-0 PBY-5A ...

NAME INSTALLATION - ASB RECTIFIER POWER UNIT

J 28F7623

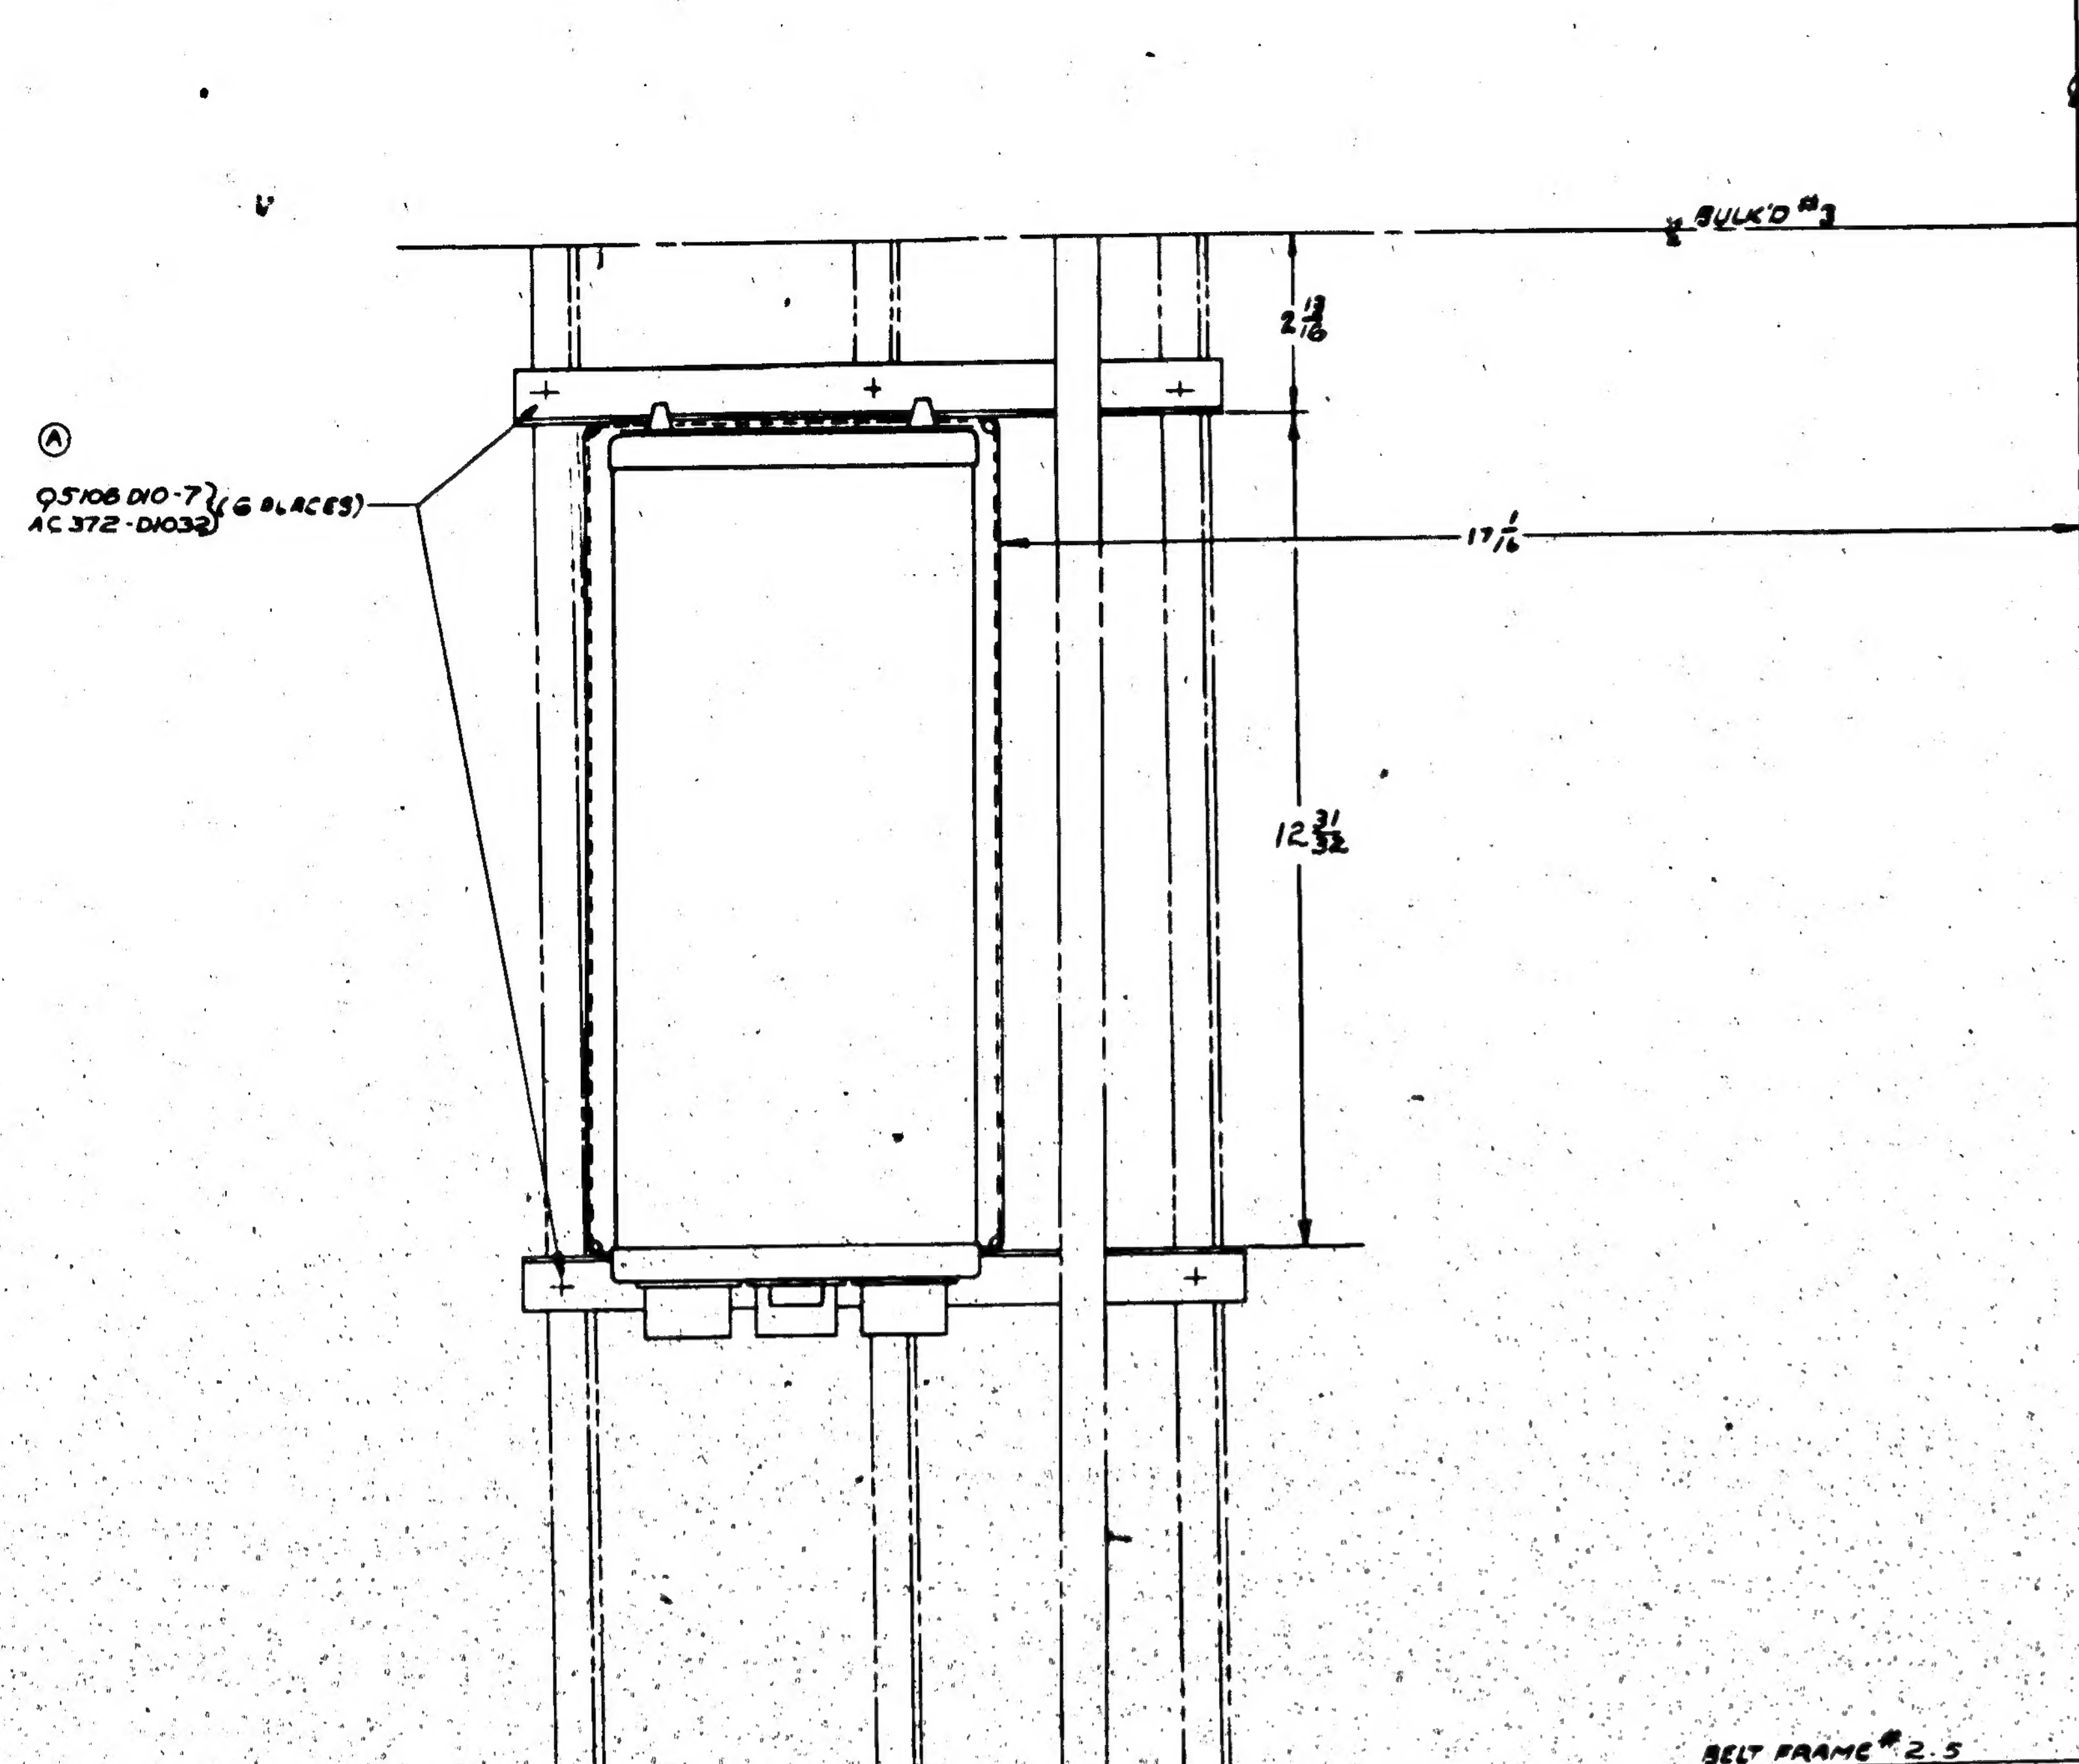
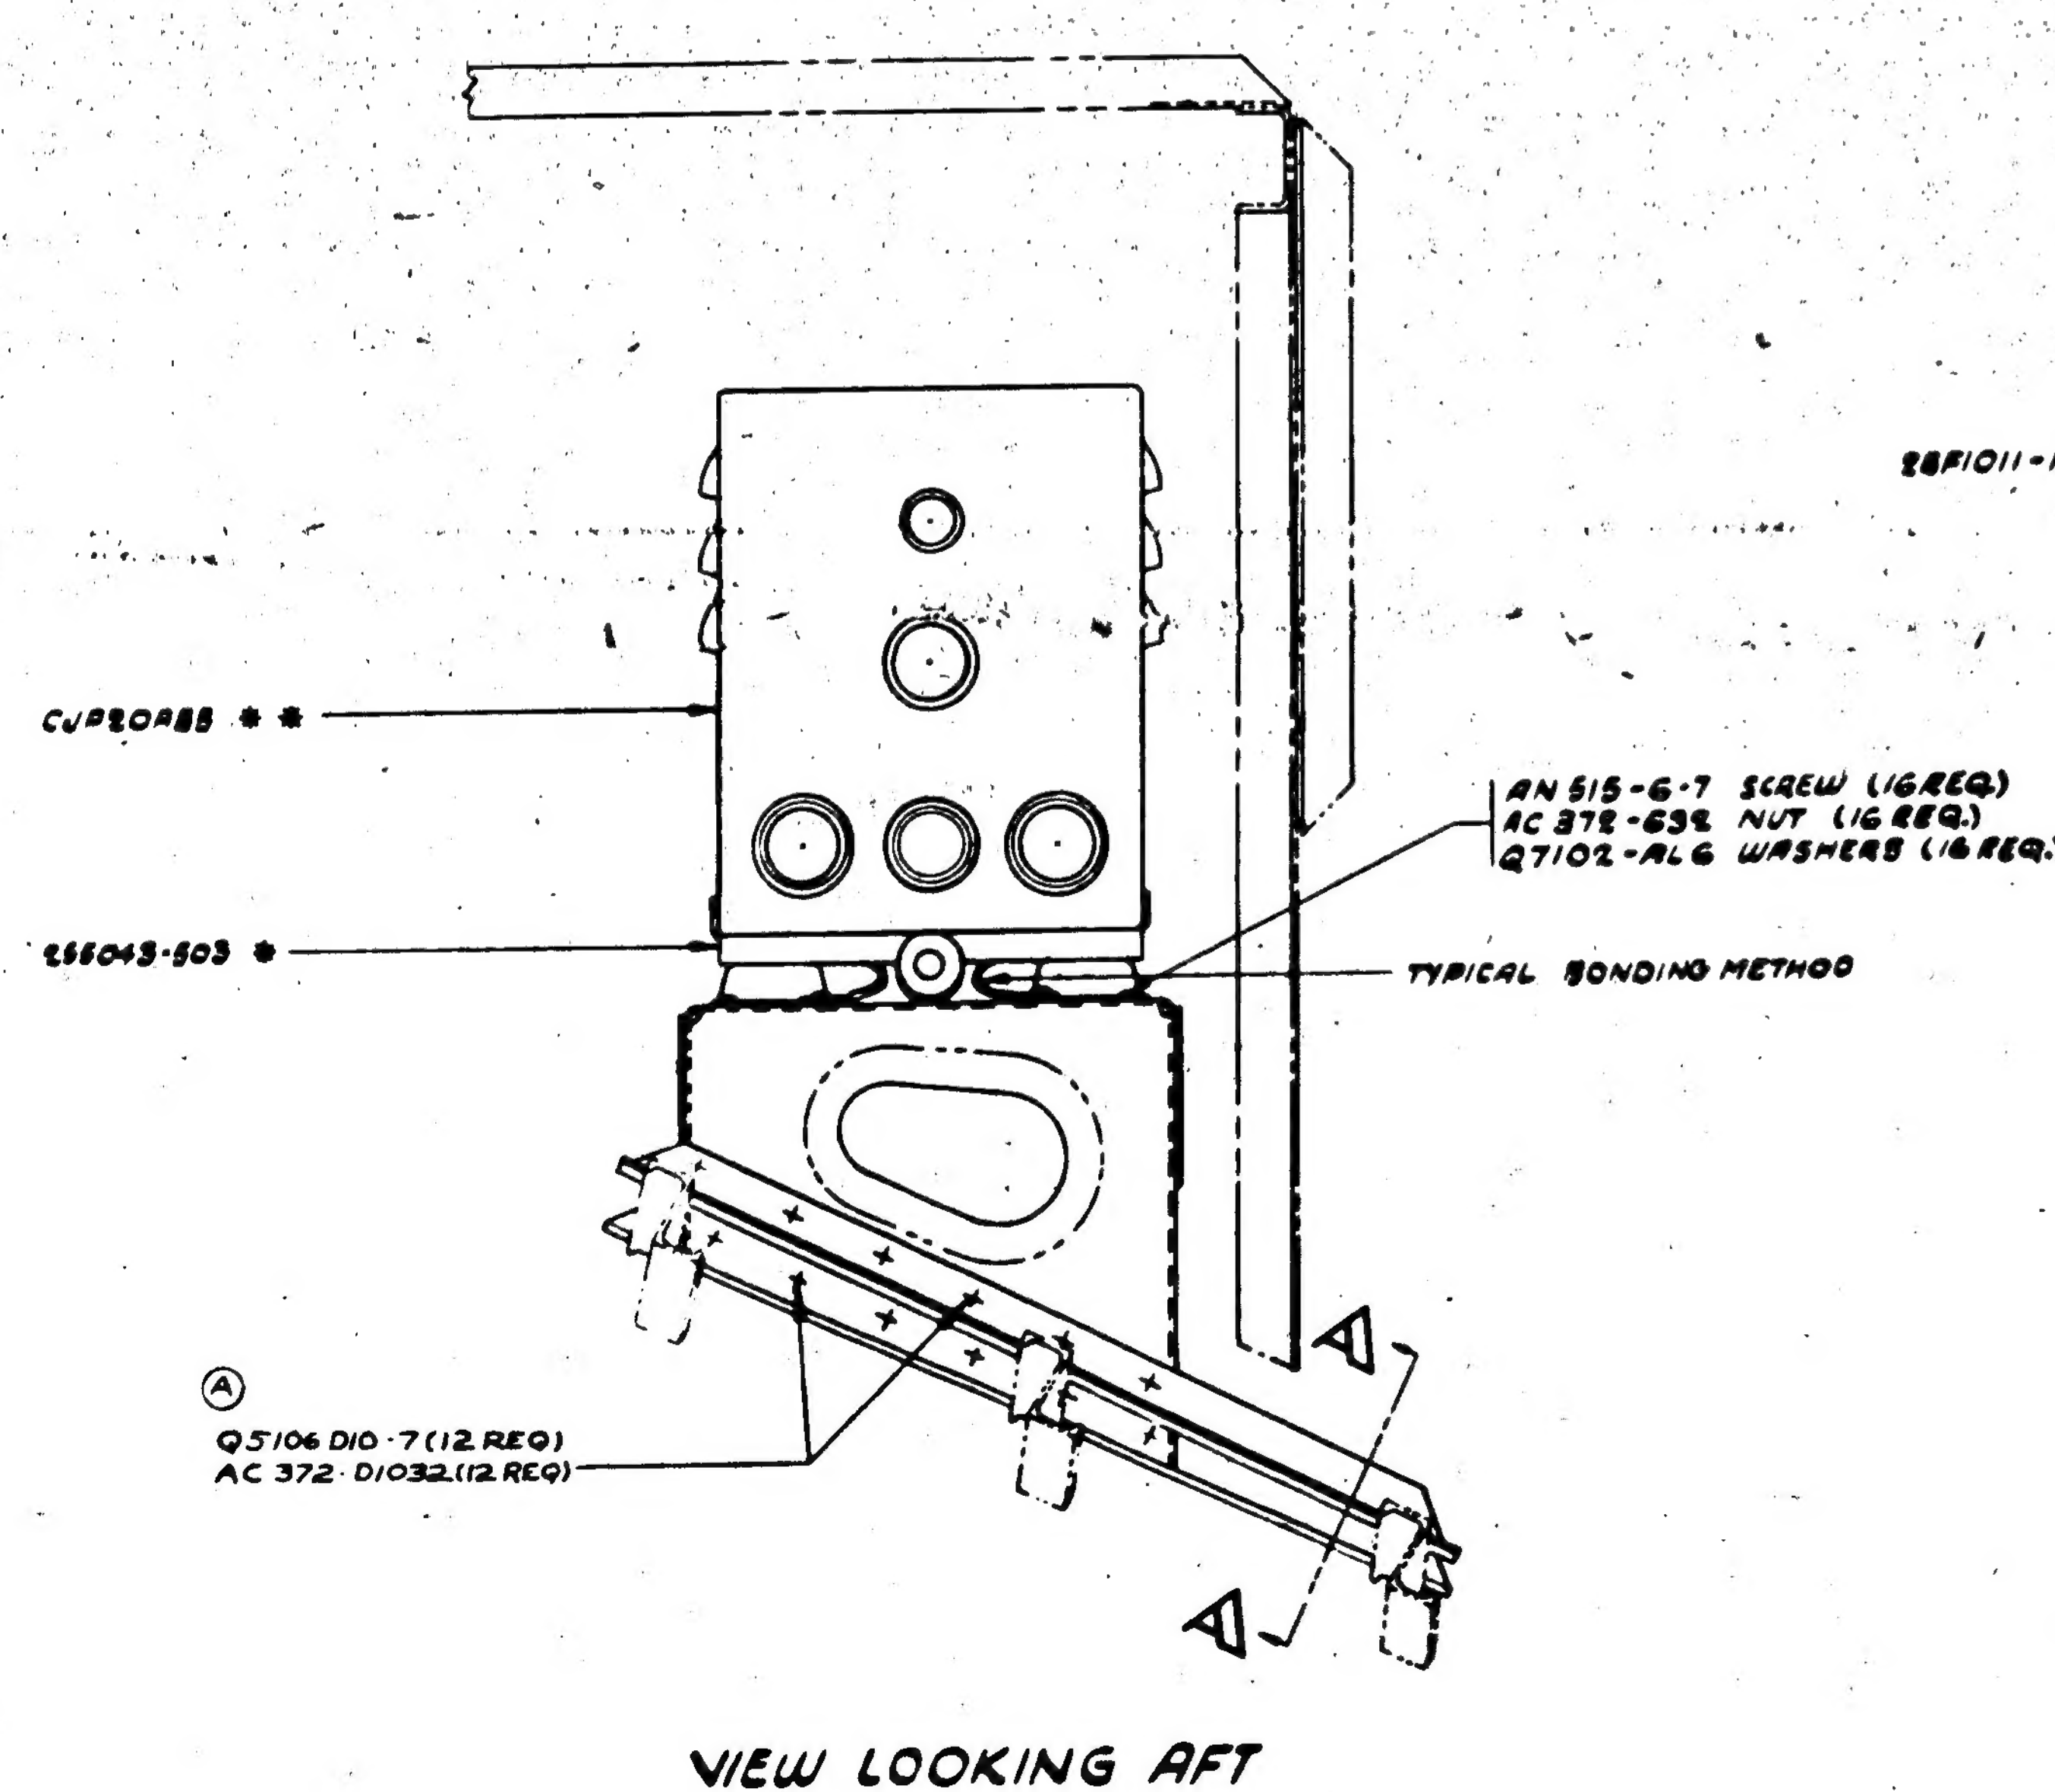
LET	ALTERATION	DATE	BY	LET	ALTERATION	DATE	BY
				A	IN B/M & ON FACE, REMOVED AN442-AD4 RIVETS (18 PLACES) & REPLACED WITH Q5106 D10-7 (18 REQ) & AC 372-D1032 (18 REQ) NEG. WT. CHG.
